SUBJECT: TRIP REPORT: NRC REVIEW OF GEOPHYSICAL DATA FOR THE
PARADOX BASIN

NRC DATA REVIEW OF GEOPHYSICAL DATA FOR THE PARADOX BASIN
16 to 18 October, 1984
Woodward-Clyde Consultant office
San Francisco, CA

GEOLOGY-GEOPHYSICAL DATA REVIEW CHECKLIST

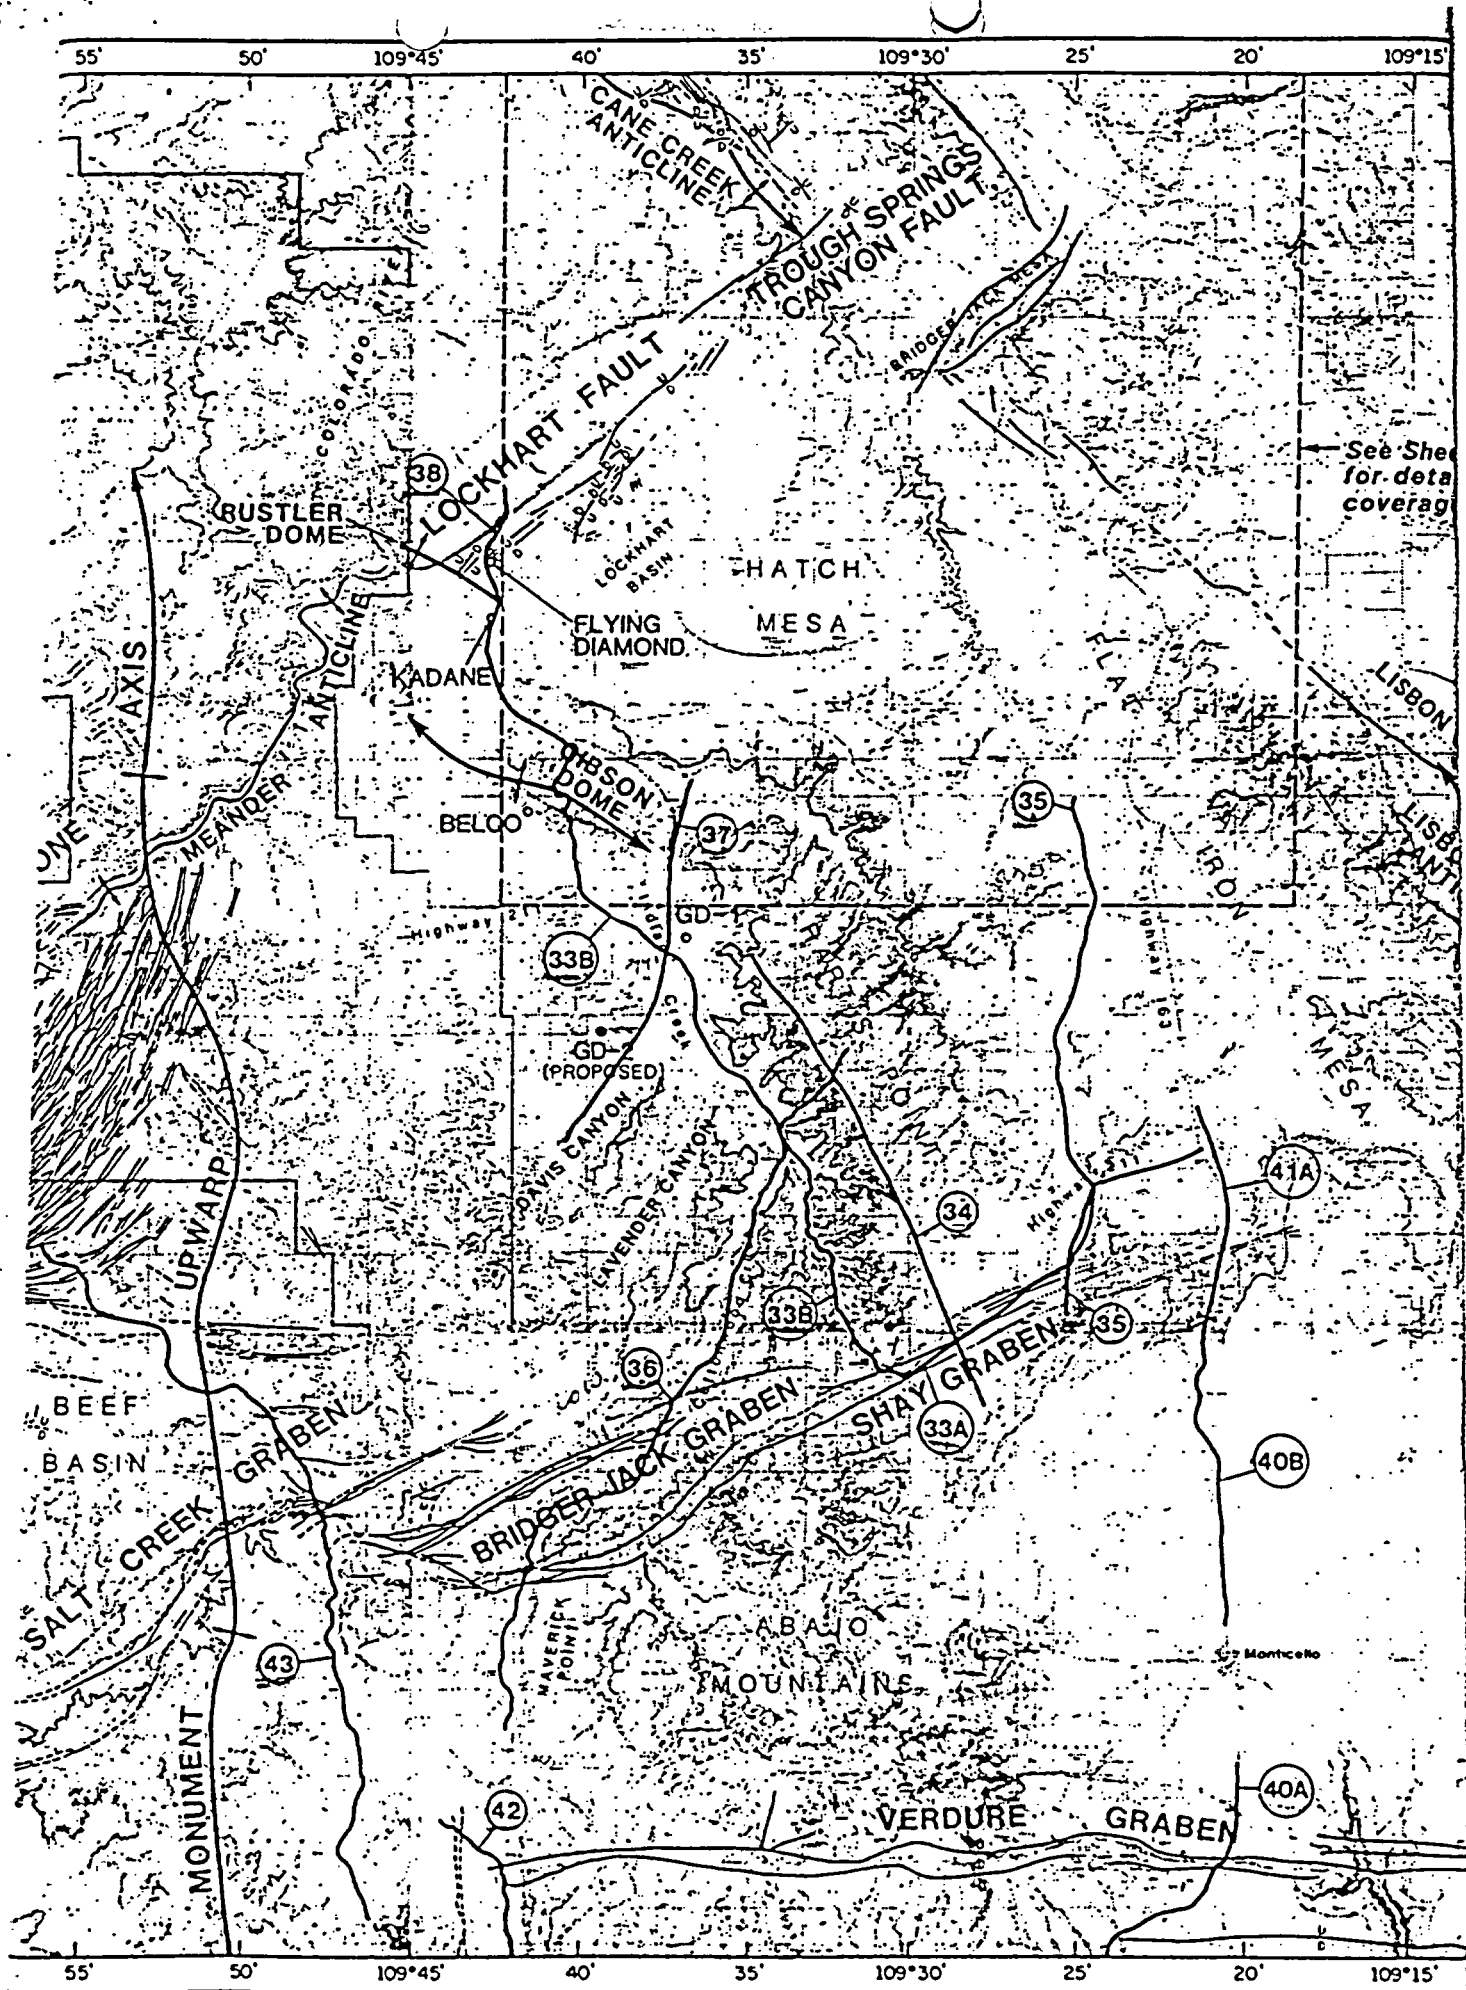
*NORMAL DATA PROCESSING USED. SEE ATTACHED HEADER SHEET
EXAMPLE FROM LINE 37 DAVIS CANYON AREA.*
